SEWAGE DISPOSAL SYSTEM

DEPARTMENT OF HEALTH AND MENTAL HYGIENE

A REPAIR

SUBDIVISION Evergreen Valley Estates LOT 35, Section 6 ROAD 3211 Evergreen Way

48105

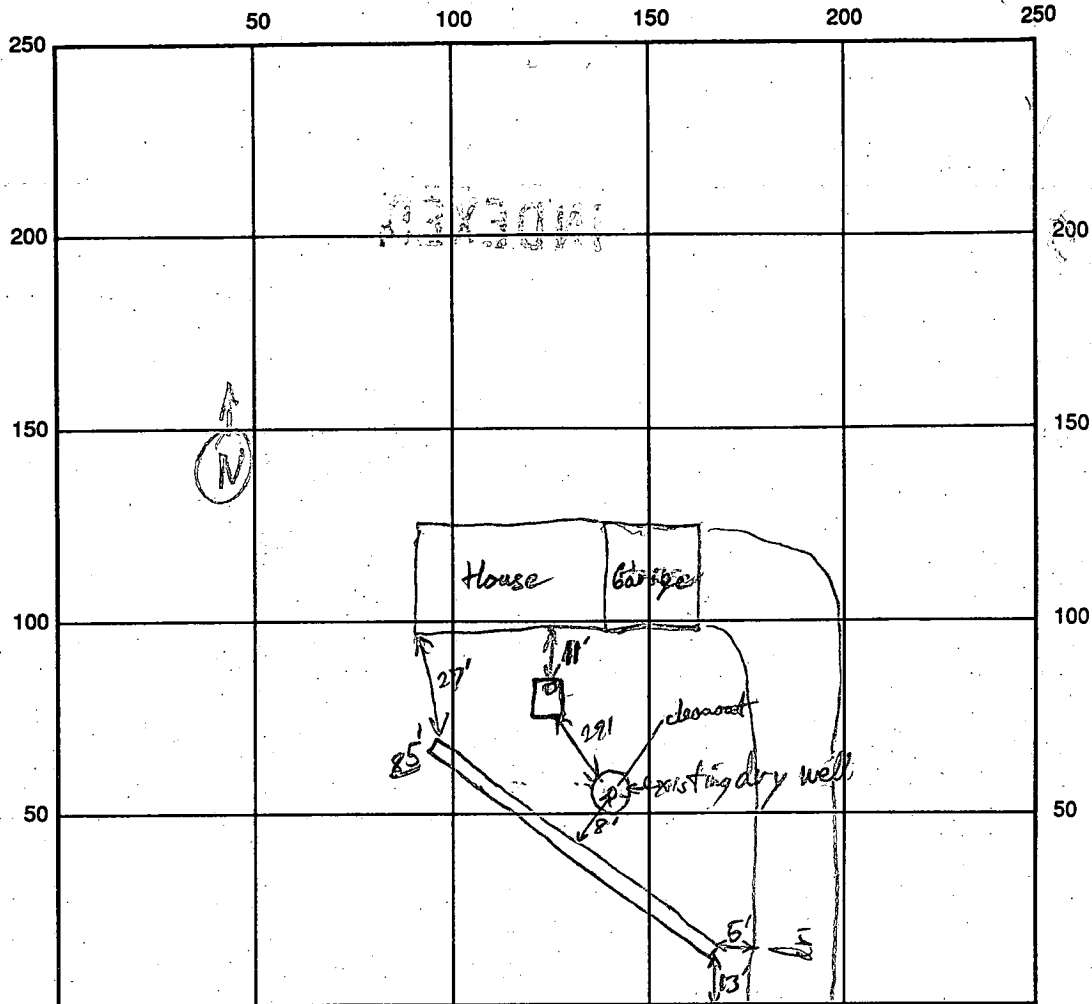
REPAIR - PURPOSE - TO REPAIR FAILING SEPTIC SYSTEM. 5/11/92
Call for inspection when ground is opened so sanitarian can recommend repair.

good soils (Sandy loam) 3 ft - 11 ft. Install one Trench, 85 ft long, 11 ft deep, 2 ft wide, inlet @ 4 ft.
Connect drain line to existing drywell. RHP 5/12/92

REMARKS: OK to fill Trench - OK to cover Trench P/P 5/12/92
